SOLUTIONS

Ford 3.8L Intake Manifold Isolator Bolts

Upper Intake Manifold Spacer Bolt Set Location

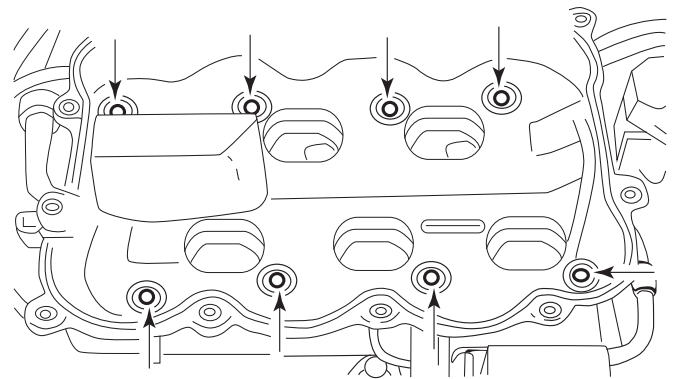
Misfiring, hard start and poor fuel economy are all issues associated with lean drivability conditions. A check engine light with a Diagnostic Trouble Code (DTC) is a common problem for the 1999-2003 Ford Windstar equipped with the 3.8L VIN 4 engine. Very often leaking intake manifold isolator bolts cause this lean condition. Experienced technicians replace the eight (8) upper intake manifold isolator grommets at the same time they replace the intake manifold gaskets. A failure to replace the grommets will result in a repeat of the lean condition.

MAHLE Original has the new isolator bolts with Fluoroelastomer (green color) grommets in packages of eight (8) – available now! We also offer the isolator grommets separately from the bolts making it possible to reuse the bolts if you desire. No more wasted trips to the dealer or downtime waiting for a separate delivery. More importantly – no more expensive comebacks!
